**ETS 300 347-1**  
pr A1

**This draft amendment A1, if approved, will modify  
the European Telecommunication Standard ETS 300 347-1 (1994)**

**Signalling Protocols and Switching (SPS);  
V interfaces at the digital Local Exchange (LE);  
V5.2 interface for support of Access Network (AN);  
Part 1: V5.2 interface specification**

**Figure 11: Link control functional model**

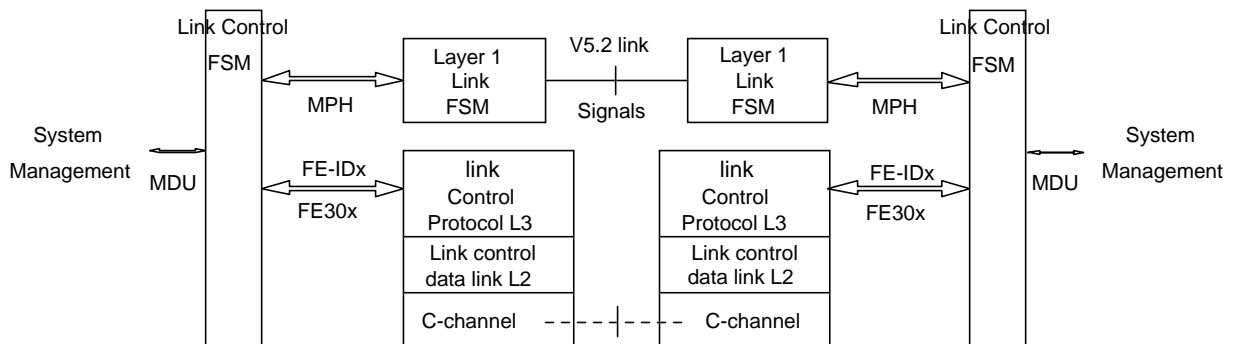
- Clause 16, figure 11: The invisible text is reconstituted from an earlier version.
- Subclause 16.2.4.5: A note is added about the sending of a notification to system management.

Add the formerly "invisible" text to figure 11:

Page 194, figure L.13.4

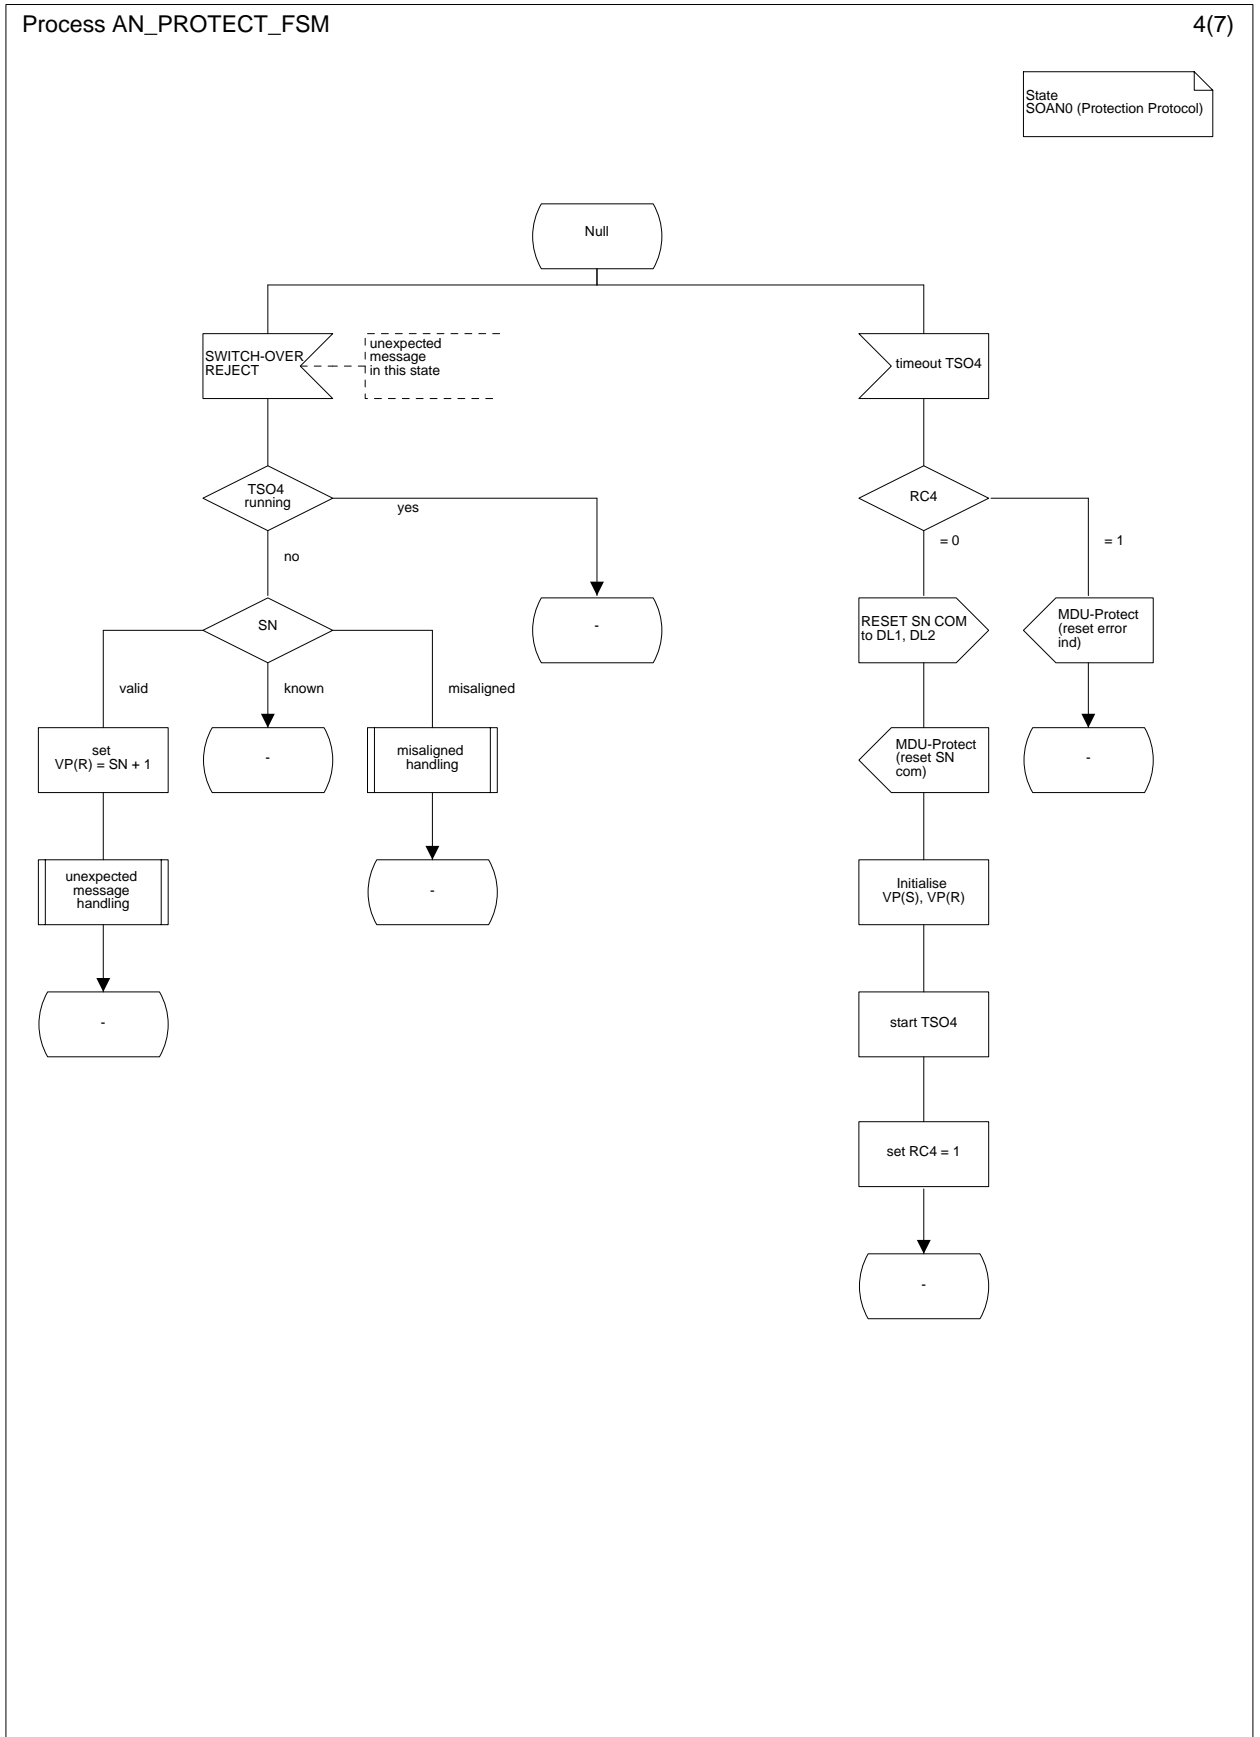
- Annex L, figure L.33.2: In the bottom diagram, the symbol for the message LINK CONTROL ACK has the wrong direction.
- Annex L, figure L.36.4: The cause for start of timer TSO4 is misalignment of sequence numbers VP(S) or VP(R) and repetition at the first timeout. Initialization of the sequence numbers V(P) or V(P) is only done in the procedure for misaligned handling according to figure L.14. This procedure is applied at the AN side and LE side.  
When a misalignment is detected and TSO4 is running, there will be no further protocol messages apart from RESET SN COM. Therefore, the sequence numbers remain in their initialization values.  
Amendment: Both figures L.13.4 and L.36.4 are corrected with a task symbol to initialize VP(S) and V(P) before start of TSO4.

Add the task symbol "initialize VP(S), VP(R)" before task symbol "start TSO4".

Page 200, figure L.15.2

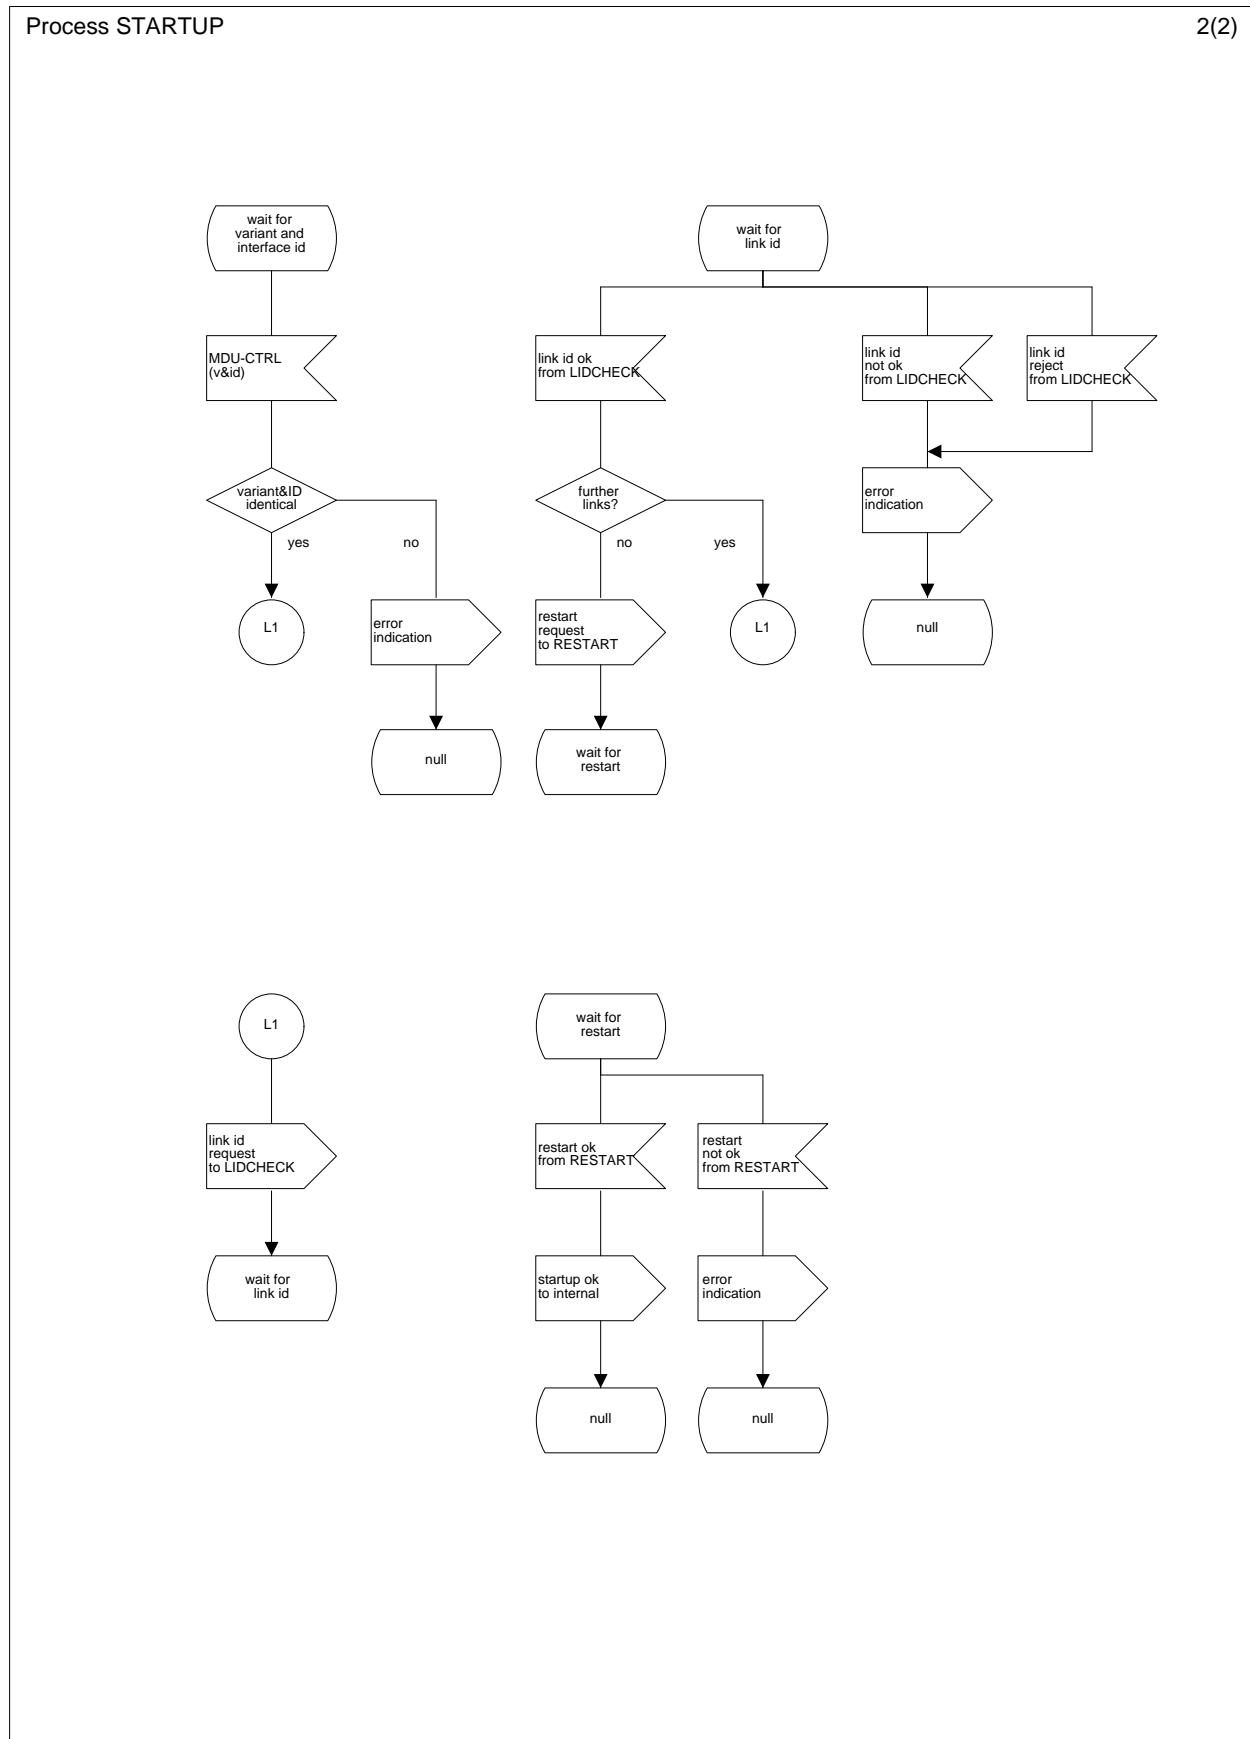
Annex L, figure L.15.2: Figure L.15.2 is contradictory to annex C, item 13), which requires that the variant and interface ID shall be checked during system start-up. Figure L.15.2 shows only a check of the interface ID.

Amendment: Update the figure by adding a decision for the correct variant.

Replace decision "ID identical" by "variant&interface ID identical".

**Figure L.23a.1: Accelerated port alignment procedures AN-side (sheet 1 of 3)**

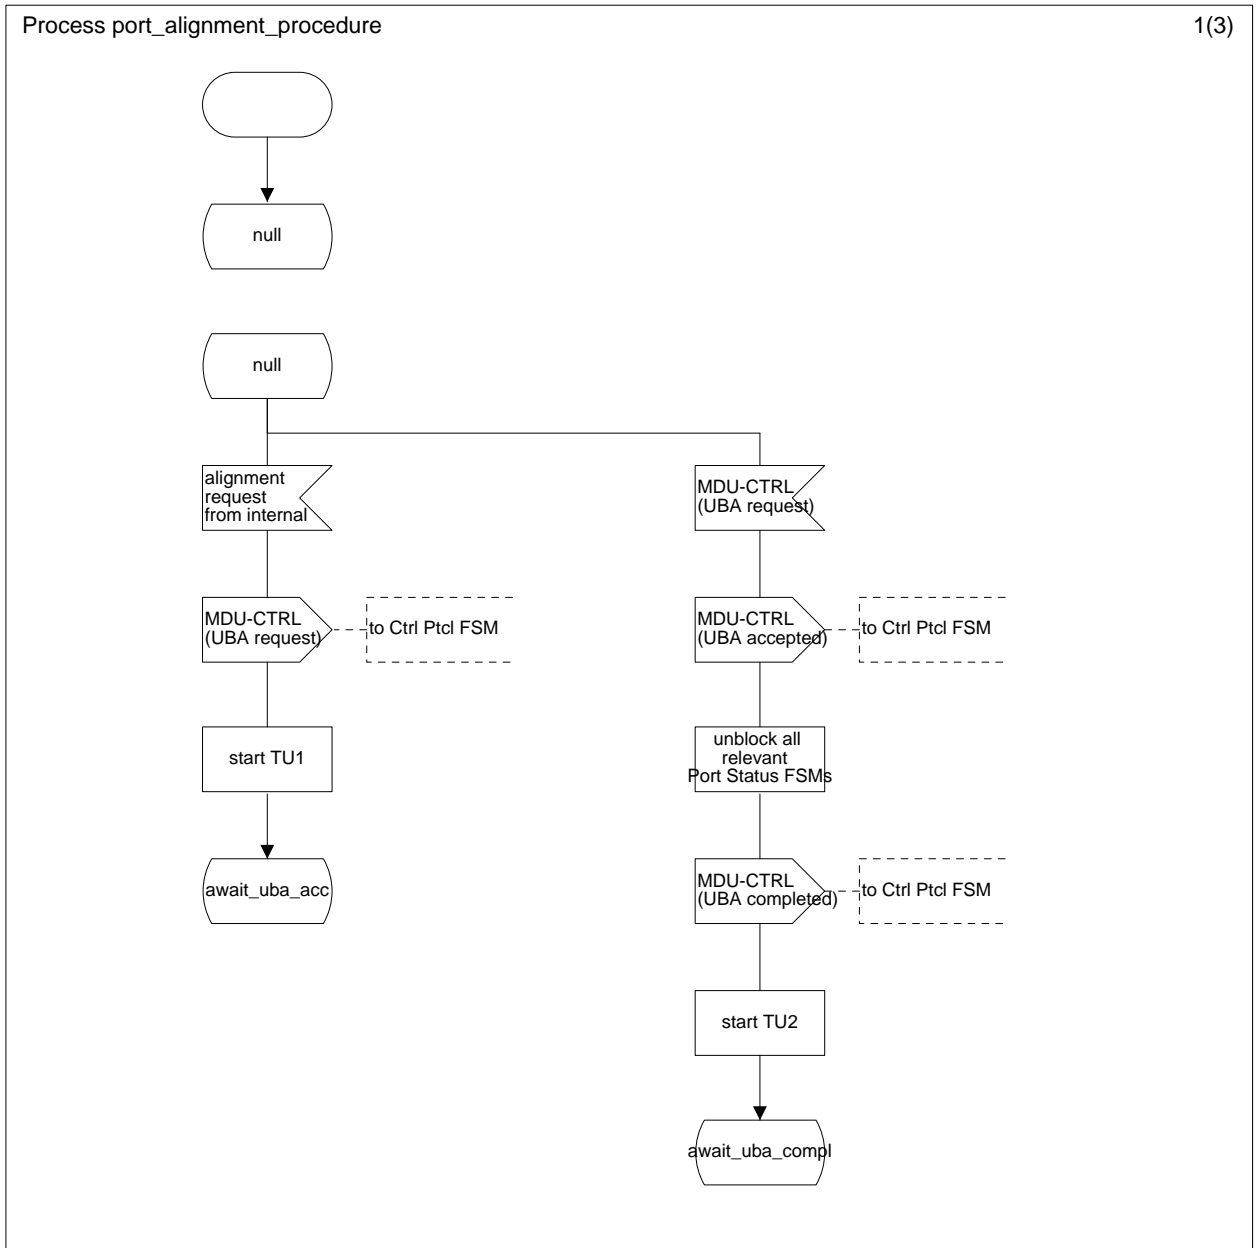
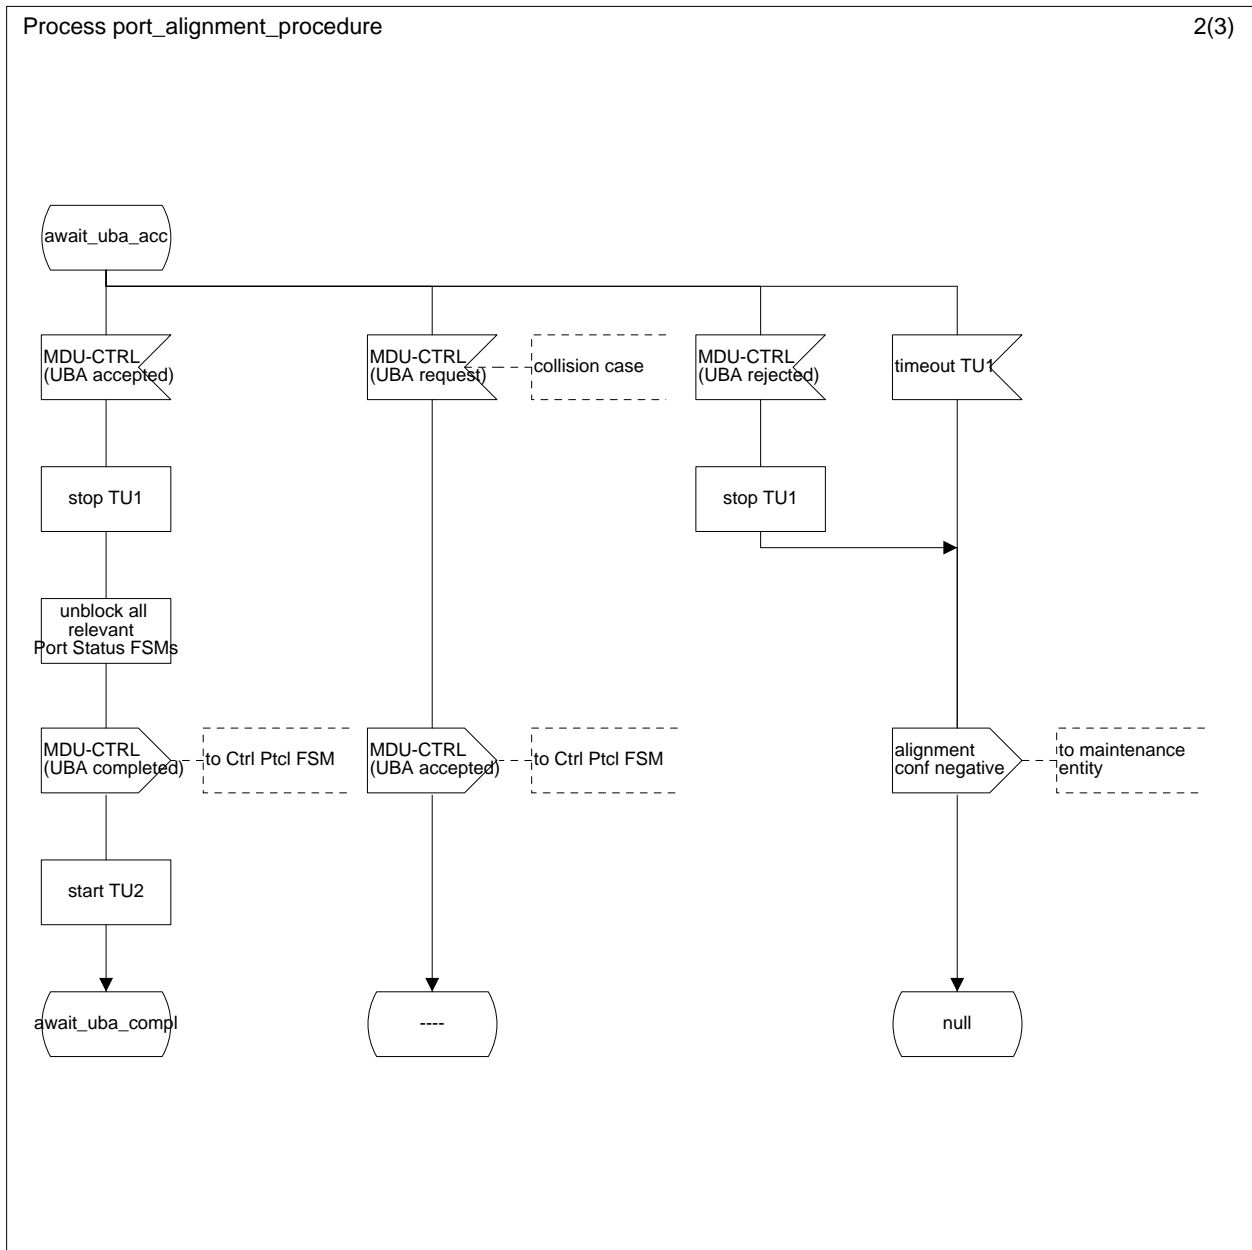
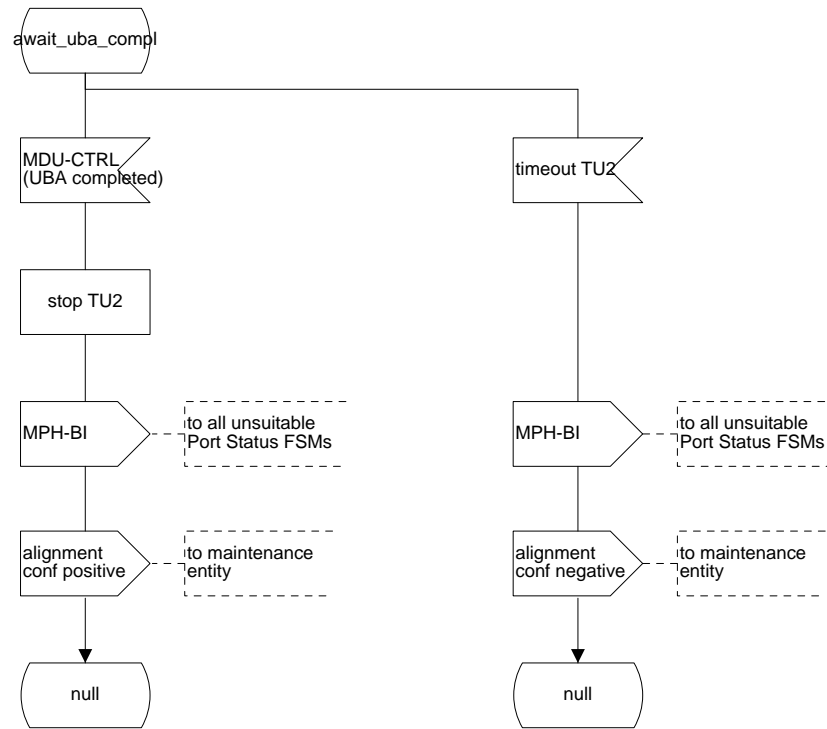
Subclause 3.1: Technical (Port state alignment procedure after interface start up):  
 Add a new definition of the Relevant user port due to the accelerated port unblocking (refer to subclause 15.4).

Subclause 15.4: Technical (Port state alignment procedure after interface start up).

Insert a new subclause L.1.8.7 after figure L.23.3

**L.1.8.7 Accelerated port alignment procedure**

Page 247, figure L.36.5, bottom left branch

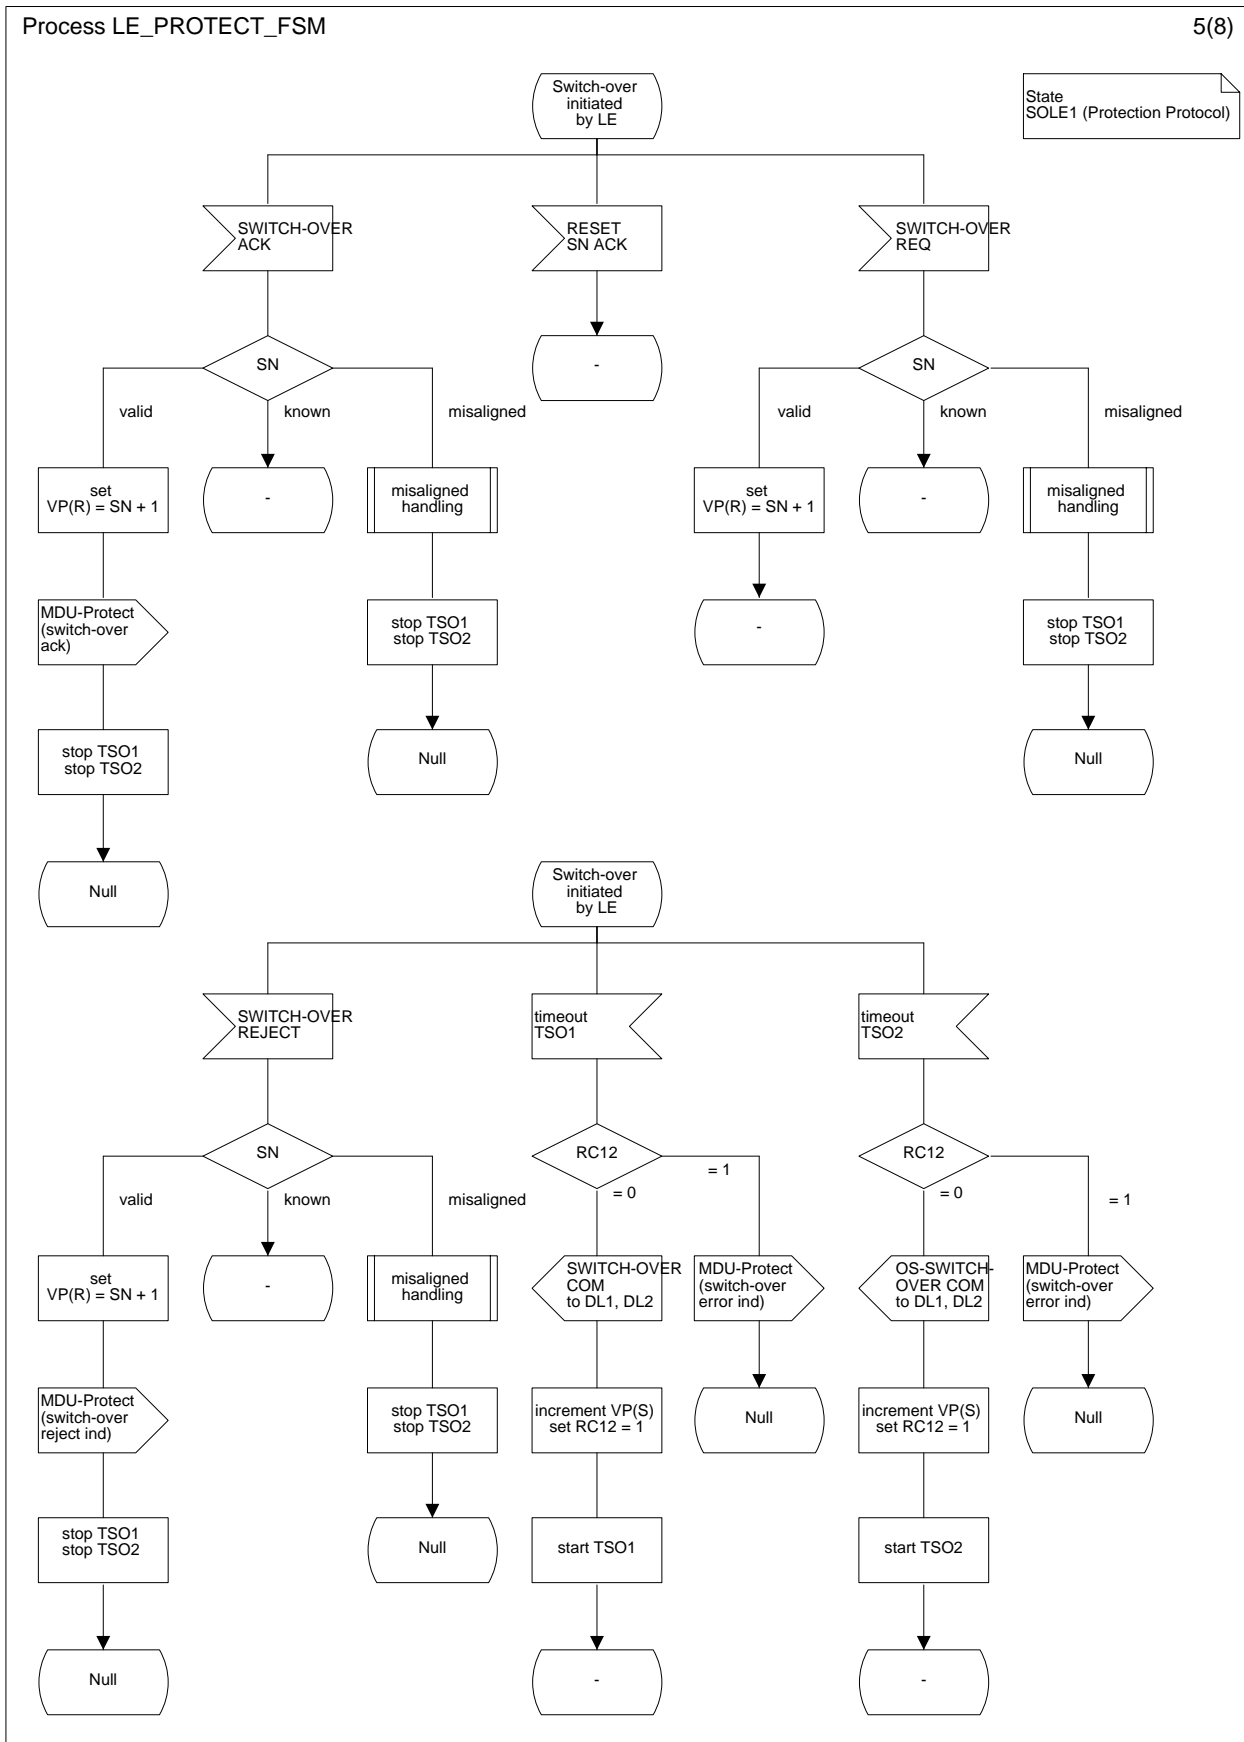
- Annex L, figure L.36.5: A stop of timer TSO2 is missing in the bottom left branch.
- Annex L, figure L.36.7: In the bottom diagram, the symbol for the message RESET SN ACK has the wrong direction.

Insert "stop TSO2" into the task symbol "stop TSO1".
